INITIAL FIRE SAFETY INSPECTION REPORT

Columbia Apparels Ltd - Extension

RSC ID: 25893

Date: 06 November 2024

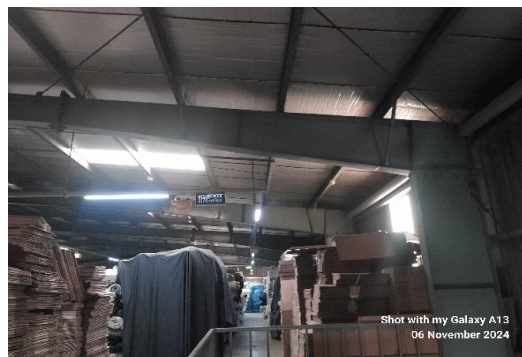
F-11	Fire Alarm & Detection System (FADS)	The factory has been installed an addressable fire alarm & detection system (NITTAN (Model: evo+5400, evo+5800) all structure such as 5-storied Main Factory Building (Extended Portion) , two Fabric Warehouse , STP building in this ID-25893 and Pre-T&CVI has been conducted combined both (ID-25893 & ID-9572) on date 19-May-2024 & Status is Pre-T&C closure verification inspection required. So Pre-T&CVI closure verification & T&C will be conducted combinedly for both ID. Location: 5-Storied store building, Two storied fabric warehouse & STP.	After complete modification work as per Pre-T&CVI report, the owner shall contact the RSC for witness of conducting the final acceptance testing of the fire detection & alarm system installation for combined both ID together. Also inspect, test and maintain the fire alarm system, and keep written records on-site, in accordance with NFPA 72.	Modification within 1 months (If require).

The row contains four photographs documenting the fire alarm system installation. From left to right: 1. A fire alarm control panel with a 'Battery Box' label. 2. A circular ceiling-mounted smoke detector. 3. A red fire alarm bell mounted on a wall. 4. A red fire alarm pull station with a label. Each photo has a small caption at the bottom right: 'Shot with my Galaxy A13 06 November 2024'.				
F-12	Fire alarm & Detection System (ITM of FADS)	Inspection, testing, and maintenance for the fire alarm system is not in accordance with NFPA 72 or as per RSC standard.	Inspect, test and maintain the fire alarm system, and keep written records on-site, in accordance with NFPA 72 (Table-14.3.1) or as per RSC standard.	Within 1 month after modification(If require).
